Access Compliance Report

Public Rights-of-Way

Intersection ID: 45505	Main Street: GINHOUSE_LN	Cross Street: MEADOW_BOTTOM_RD	Location: SW
ADA ID: 371830A4AB44	Ramp Type: PerpDiag	Initial Pass/Fail: Fail	Overall Compliance: No
Codes/Mitigation Info/Possible Solution		Field Measurements/Component Compliance	
Severity Score: 8.75

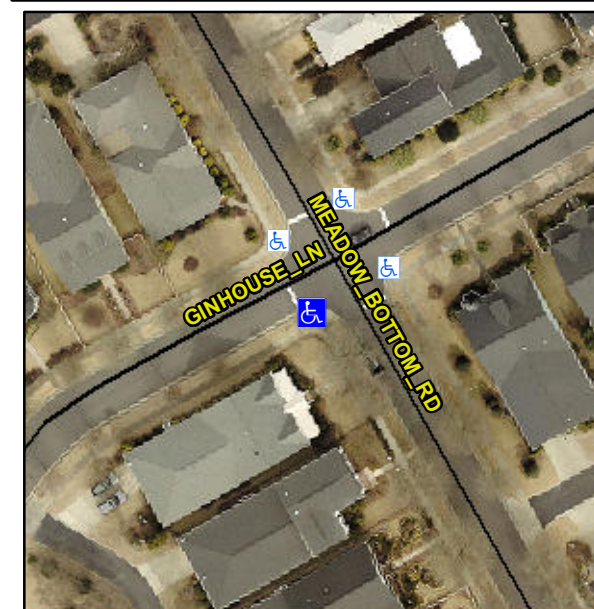
Not Found, R304.5.1

Compliance	Description	Data	Compliance	Description	Data
N/A	Ramp Length (in)	72.0	Yes	Ramp Slope (%)	6.0
No	Ramp Width (in)	37.0	Yes	Ramp XSlope (%)	0.1
N/A	Flare Type LT	N/A	N/A	Flare Type RT	N/A
N/A	Flare Slope LT (%)	N/A	N/A	Flare Slope RT (%)	N/A
N/A	Flare Traversable LT?	N/A	N/A	Flare Traversable RT?	N/A
N/A	Landing Length (in)	N/A	N/A	DWS Provided?	N/A
N/A	Landing Width (in)	N/A	N/A	DWS Contrast?	N/A
N/A	Landing Slope (%)	N/A	N/A	DWS Length (in)	N/A
N/A	Landing X Slope (%)	N/A	N/A	DWS Full Width?	N/A
N/A	Landing Curb? (Y/N)	N/A	N/A	DWS Offset (in)	N/A
N/A	Shared Landing?	N/A			
N/A	Gutter Ponding?	N/A	N/A	Gutter Slope (%)	N/A
N/A	Gutter Lip Ht (in)	N/A	N/A	Gutter X Slope (%)	N/A
N/A	Painted X Walk1?	No	N/A	Painted X Walk2?	No
	X Walk 1 Direction	To NE		X Walk 2 Direction	To NW
N/A	X Walk 1 Width (in)	N/A	N/A	X Walk 2 Width (in)	N/A
	X Walk 1 Slope (%)	3.8		X Walk 2 Slope (%)	2.5
	X Walk 1 X Slope (%)	1.0		X Walk 2 X Slope (%)	2.1

Remove & Replace Curb Ramp With Two New Directional Ramps or Equivalent.
